APPARATUS AFFECTED: All 33 Call Control Units except UCC21 and UCC22.

PART AFFECTED: TP178831 Receptacle Connector
TP178832 Adapter Plate
TP181240 Screw W/Lockwasher
TP182710 Upper Bracket
TP186426 Bracket
TP186628 Upper Bracket
TP197078 Mounting Plate
TP319258 Mounting Plate

REASON: (1) To conform to latest Underwriters Laboratories requirements.

TP301713 RECEPTACLE CONNECTOR

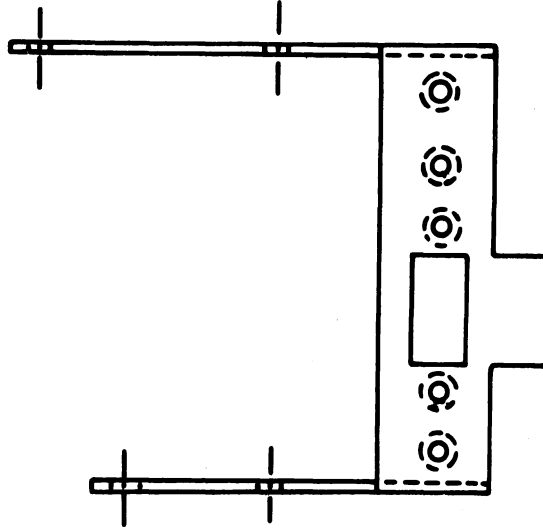
(1A) The TP178831 receptacle connector and TP178832 adapter plate are replaced by a new TP301713 receptacle connector. The TP182710 upper bracket is replaced by the new TP186628 upper bracket. The two TP181240 screws w/lockwashers which mount the above receptacle connector and adapter plate to the old TP182710 upper bracket are removed.
